March 31, 1982
AW-82-21

APPLICATION FOR WITHHOLDING PROPRIETARY
INFORMATION FROM PUBLIC DISCLOSURE

SUBJECT: Response to Questions on WCAP-9561, "Bart-A1: A Computer Code for the Best Estimate Analysis of Reflood Transients" (Proprietary)

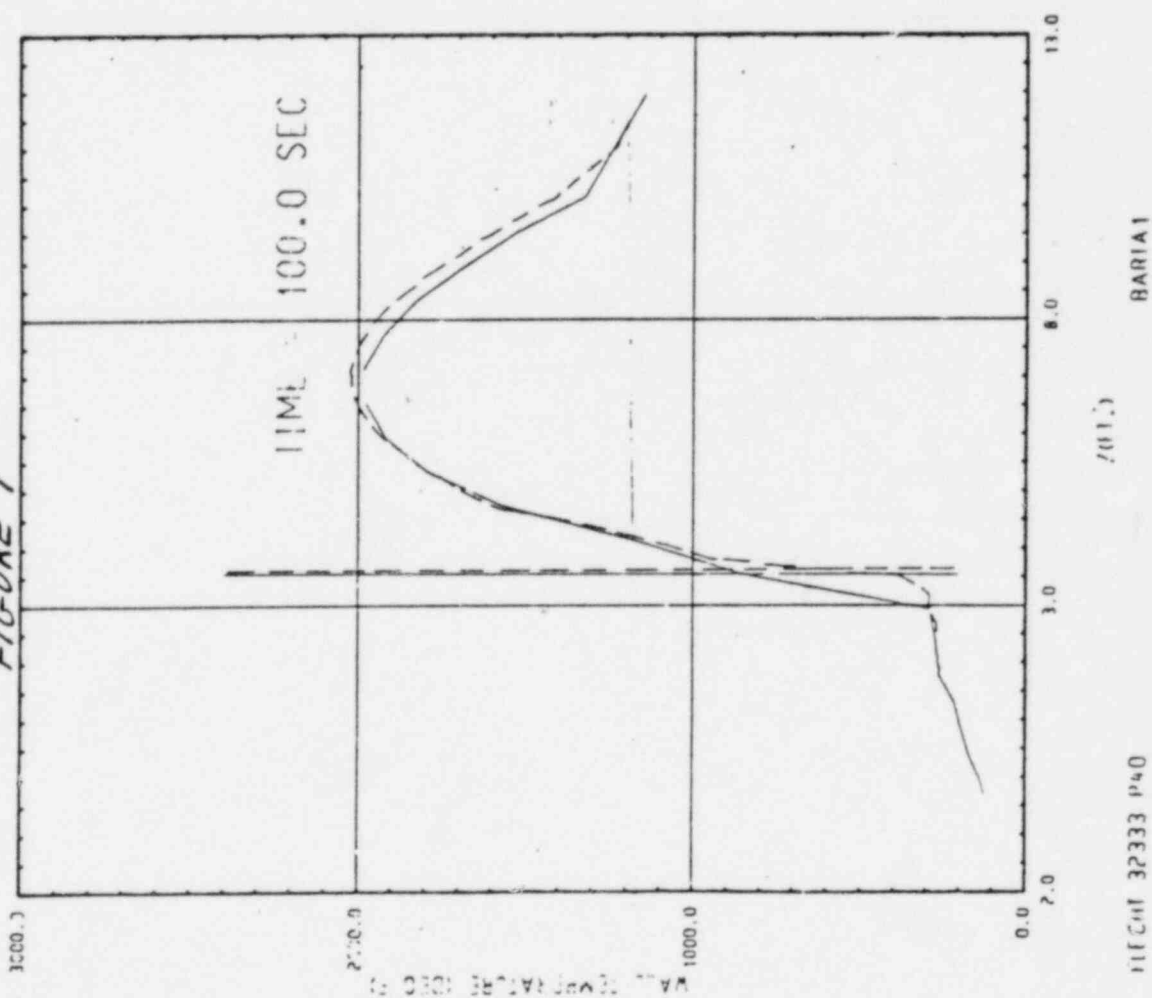
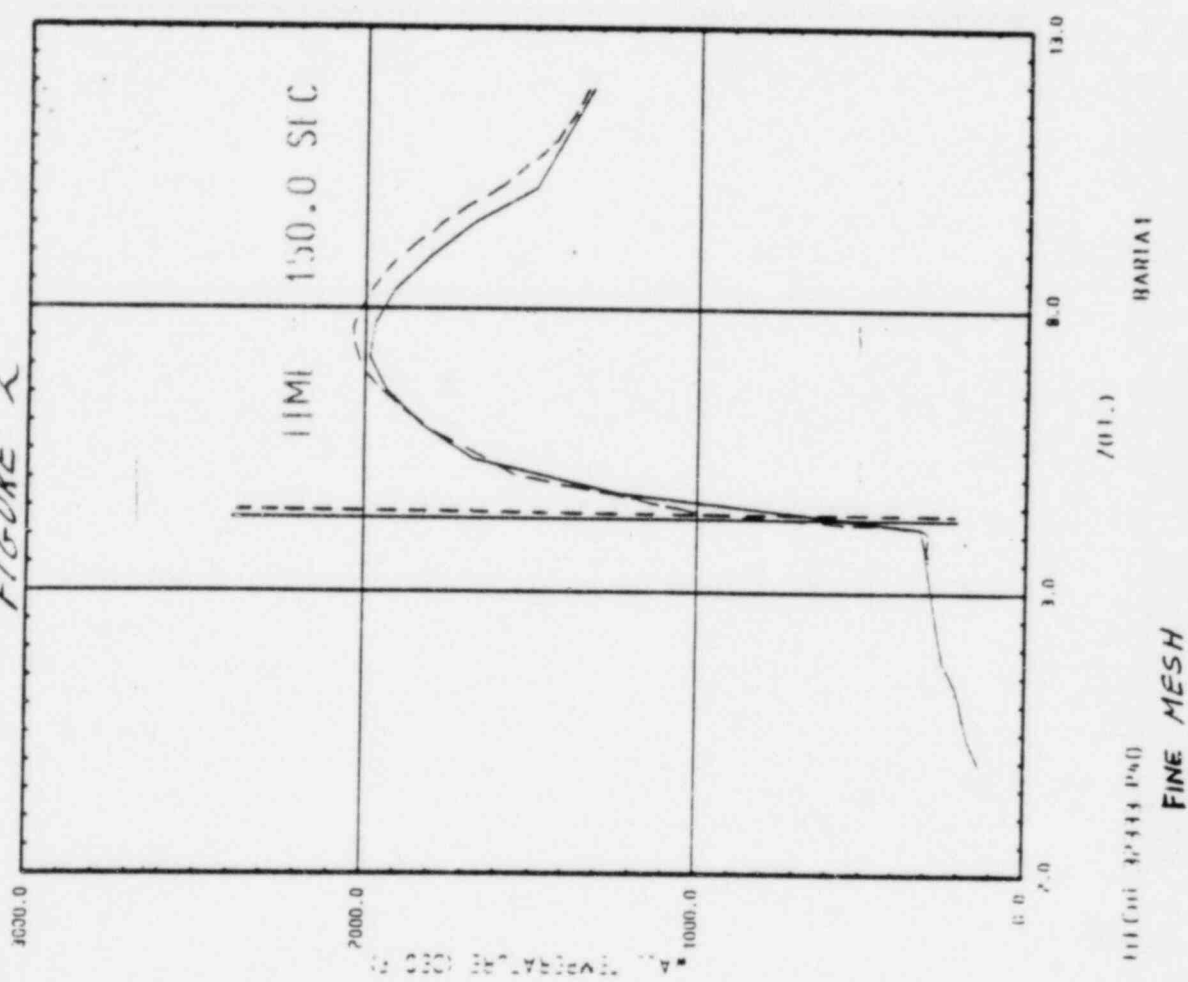
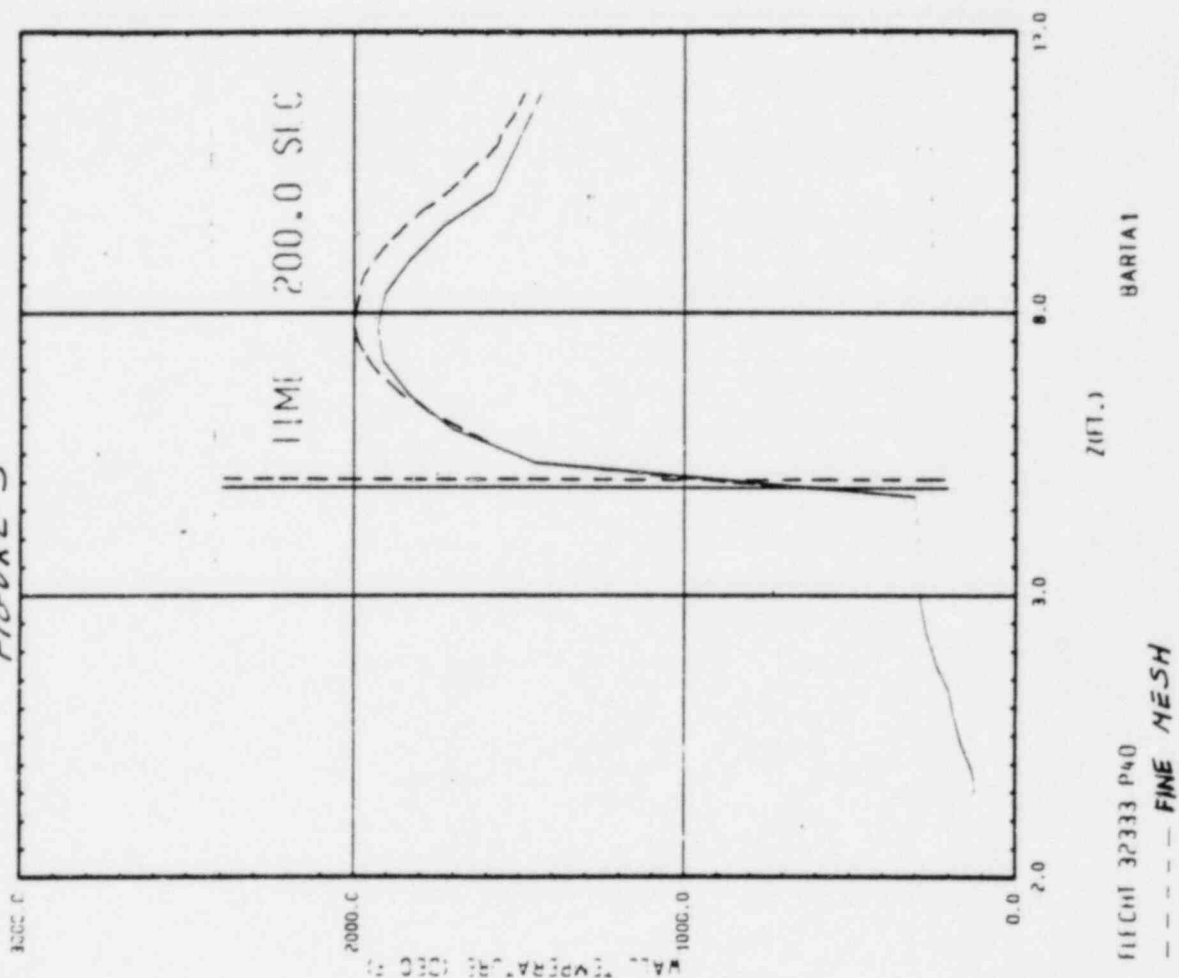
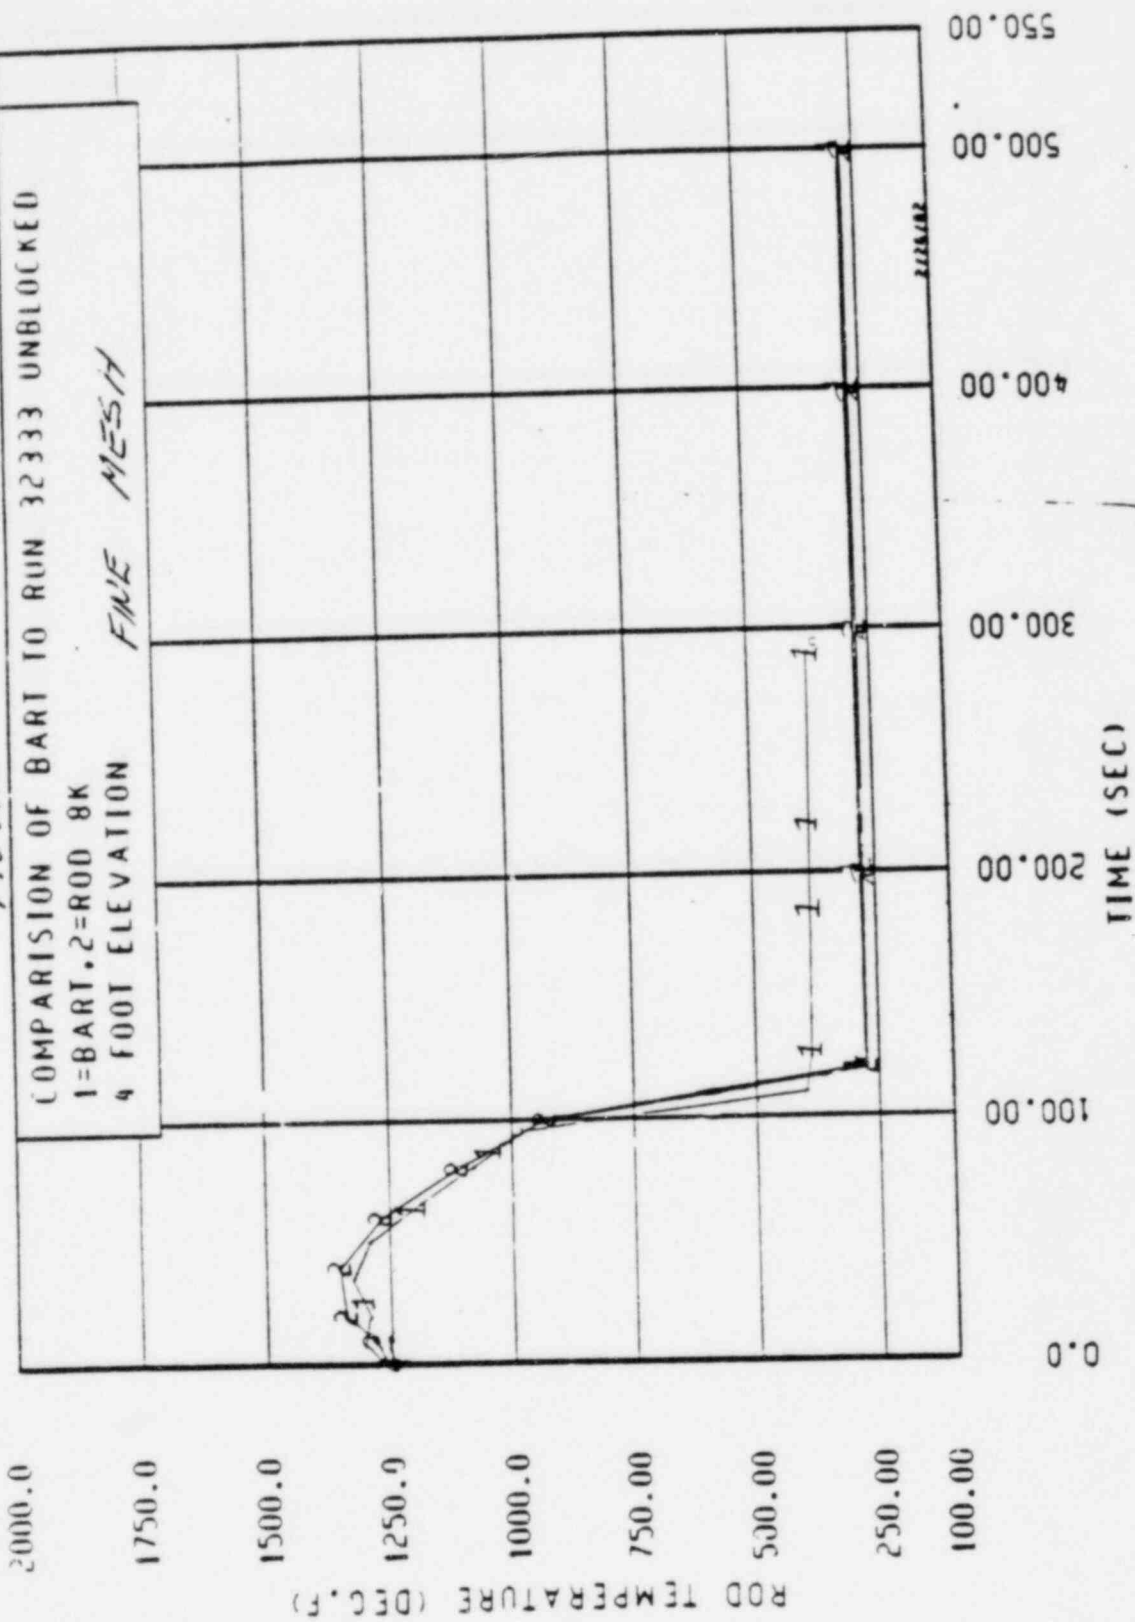
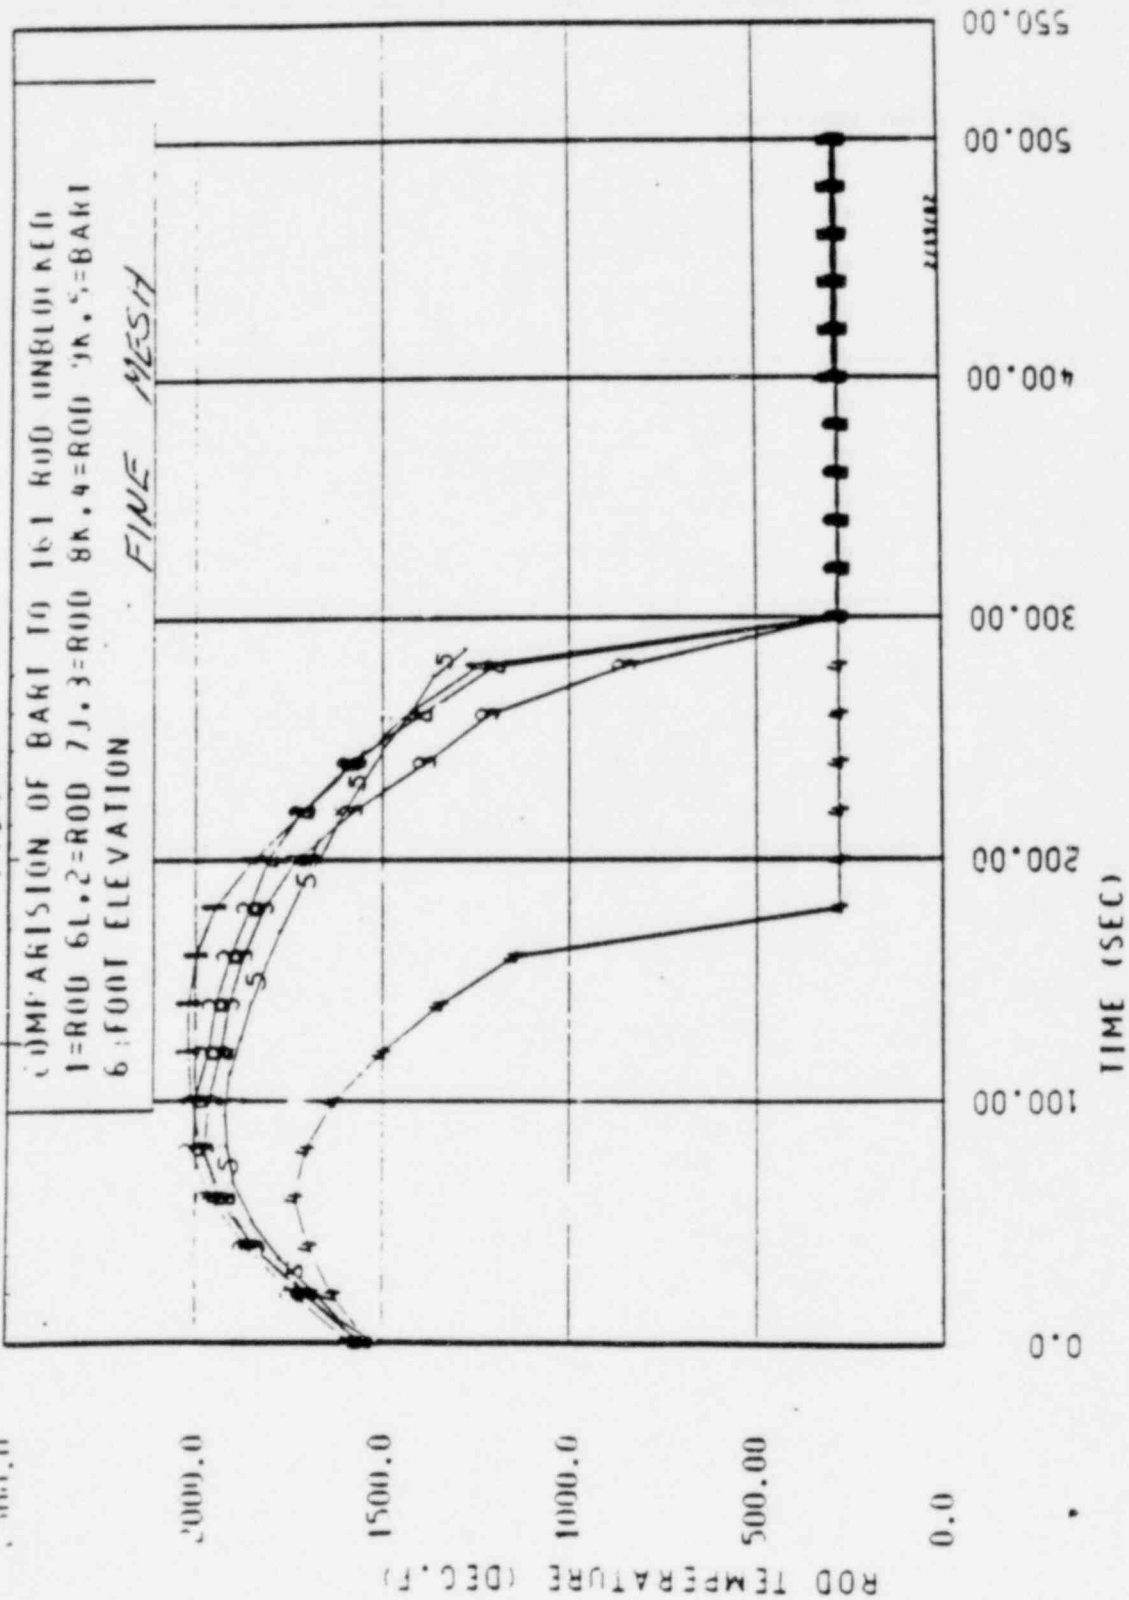
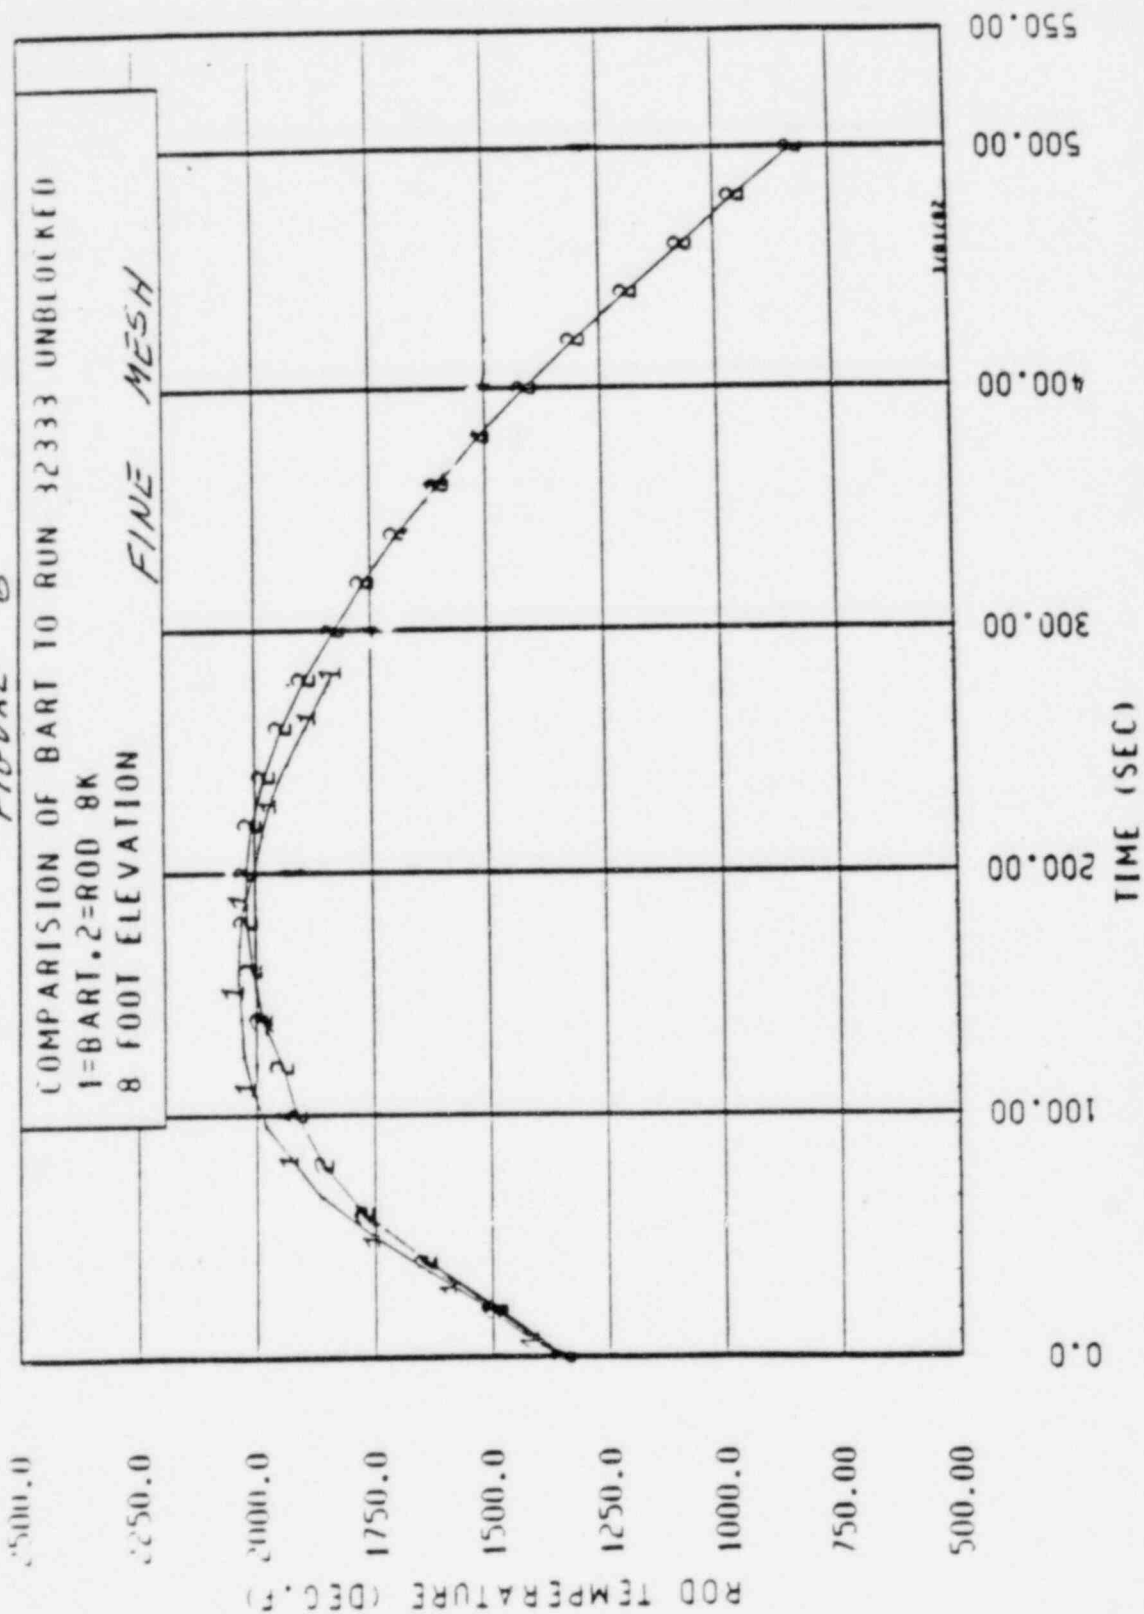
1.) How sensitive are the BART results to axial mesh size?

To investigate BART sensitivity to mesh size, the BART calculation for run 32333 (see response to Question-4, Section 6.0) was repeated with the axial mesh size reduced by a factor of two.

Figure 1 - 3 show that there is an overall increase in calculated temperature of about 100°F. Figures 4 to 7 show that the prediction still compares well with data.
